UN/SCETDG/49/INF.4/Add.4

**Issues relating to the Globally Harmonized System
of Classification and Labelling of Chemicals: Use
of the Manual of Tests and Criteria in the context
of the GHS**

Revision of the Manual of Tests and Criteria: Parts III, IV and V (Chapters 30 to 51)

**Transmitted by the Chairman of the Working Group on Explosives on
behalf of the Working Group**

Figure 33.2-4.3 : FLOW CHART FOR CLASSIFICATION OF ASSIGNING READILY COMBUSTIBLE FLAMMABLE SOLIDS, EXCEPT METAL POWDERS, TO DIVISION 4.1

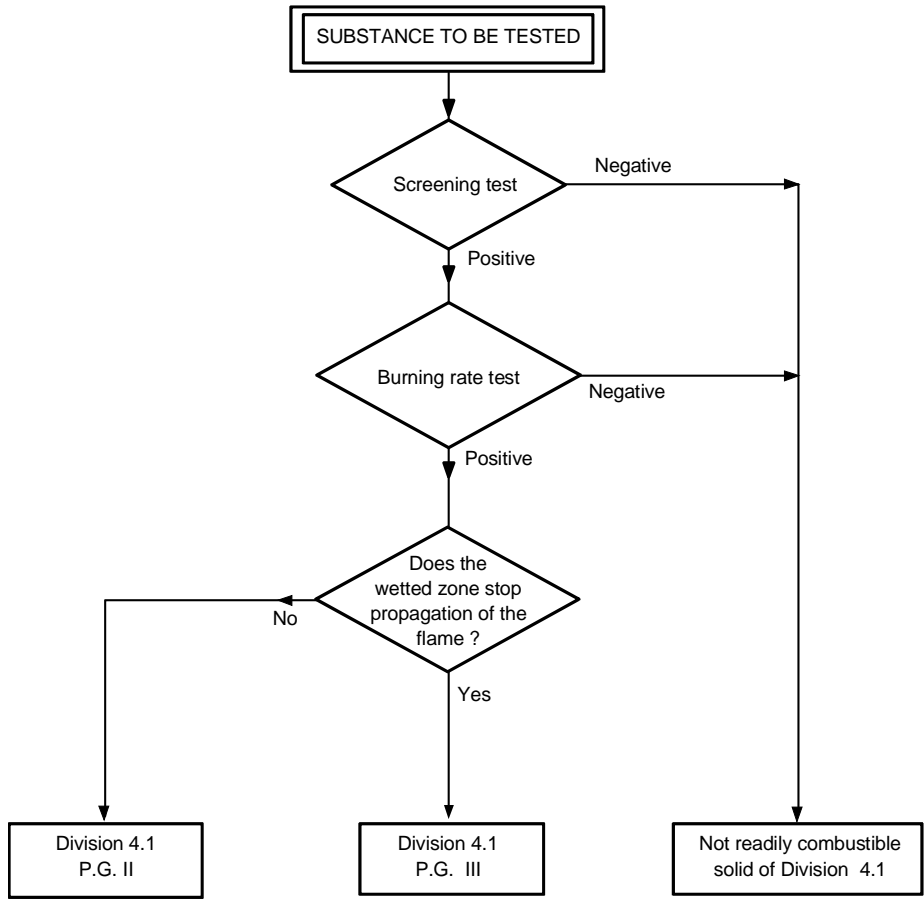
~~33.2.1.1~~ Section ~~33.2.1.3~~ presents the United Nations scheme for the classification of readily combustible solids of Division 4.1 (see [Chapter 2.4](#), sub-section 2.4.2.2 of the Model Regulations [and Chapter 2.7 of the GHS](#)). The text should be used in conjunction with the classification principles given in [Chapter 2.4](#), paragraphs 2.4.2.2.2 and 2.4.2.2.3 of the Model Regulations, [Chapter 2.7, paragraph 2.7.2 of the GHS](#), the flow chart given in Figure ~~33.2.1.3~~ and the test prescription given ~~here~~ in ~~33.2.1.4~~.

Figure 33.3.1-33.5.3.3.1: CLASSIFICATION OF SELF-HEATING SUBSTANCES

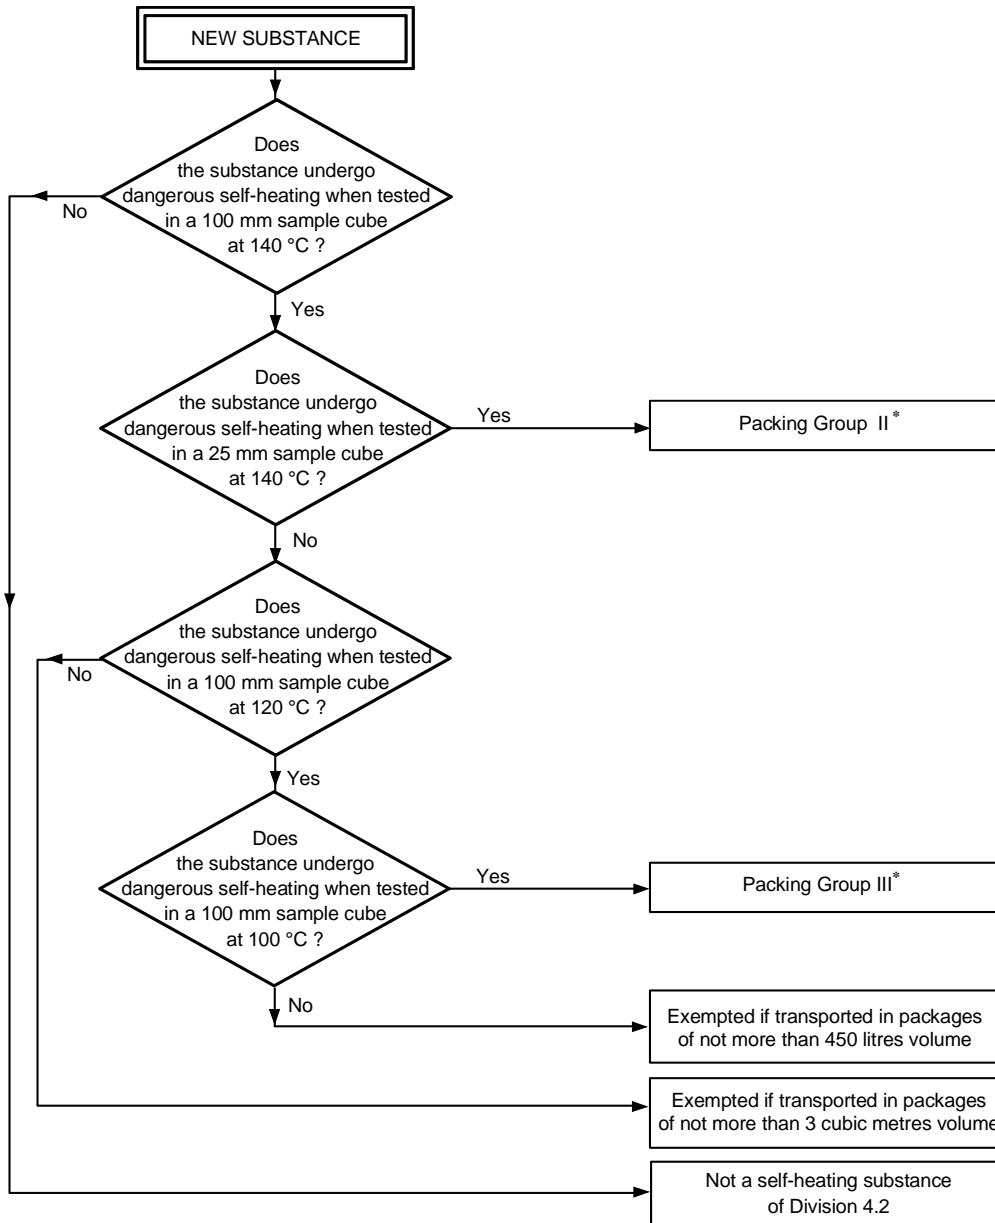
Comment [Ed8]: there are other experiences that seems to contradict this

* Substances with a temperature for spontaneous combustion higher than 50 °C for 27 m³ should not be classified in Division 4.2 as self-heating substances.
Replace “Packing group II” with “Packing group II / Category 1” and “Packing group III” with “Packing group III / Category 2” and “...if transported...” with “...if packaged...”(two times)
